CITY OF ALBUQUERQUE

RE: 5720 McMahon Blvd NW –McMahon Market Place New Shell Building
Grading Plan and Drainage Report
Stamp Date: 9/15/17
Hydrology File: A11D011H

GRADING & DRAINAGE PLAN

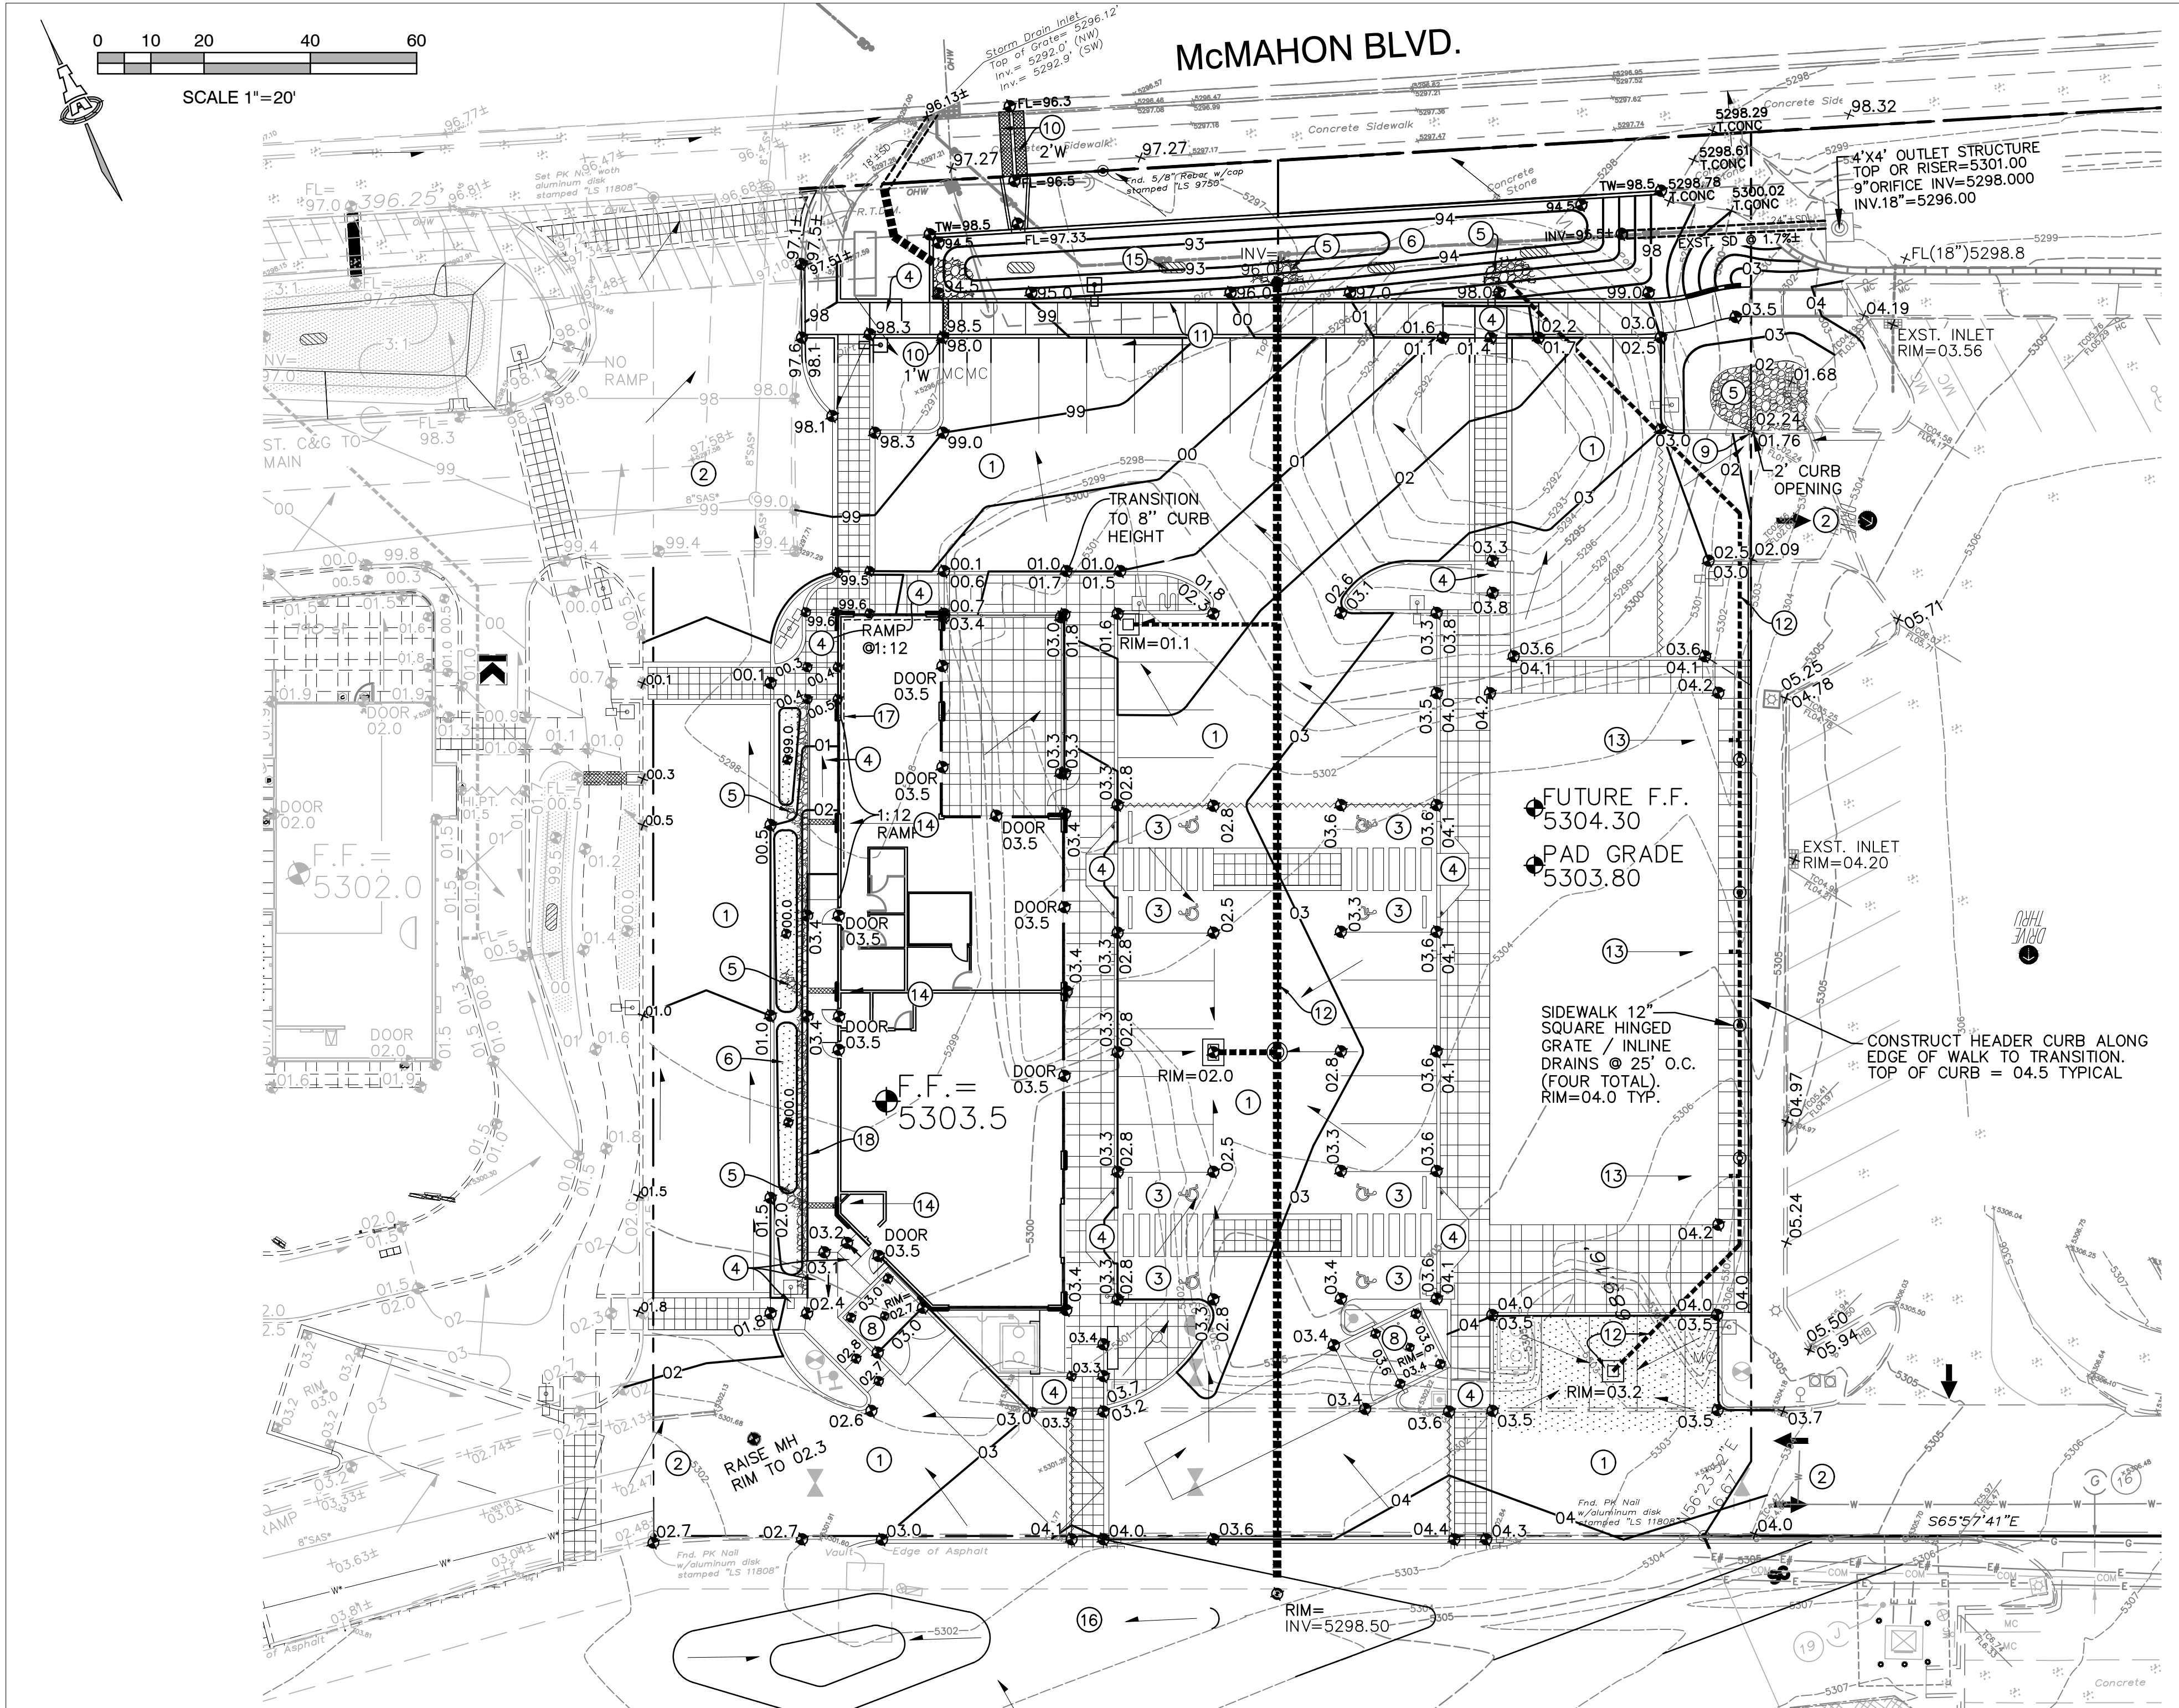
What is the future Lot 9 discharge in the storm sewer system? Are you sure that an 18 inch pipe will be able to handle the discharge from Lot 9 and this tract? I would have expected to see a 24 inch pipe.

I am reviewing this project and have only one comment. What is the pipe size for the private storm drain. I do not see the sizes on the Proposed Storm Drain System on Sheet CG-2. Please add the pipe sizes and then email me a pdf of the sheet with the engineer stamp date of 9-15-17. I will then send you the approval letter. Don't forget to include the drainage of the future Lot 9 so that the storm pipe to be installed can handle the all future flows.

Per the calculations provided, the pond is permitted to discharge max 17.65 cfs in the fully developed condition to limit the discharge to 41.55 cfs. The pond is not able to detain the difference so, as Lot 9 develops, detention will be provided.

The 18" diameter system is sufficient for the required Q although a 24" would be needed if detention were not required on Lot 9.

Attached is the revised sheet CG-2 with the pipe sizes shown.
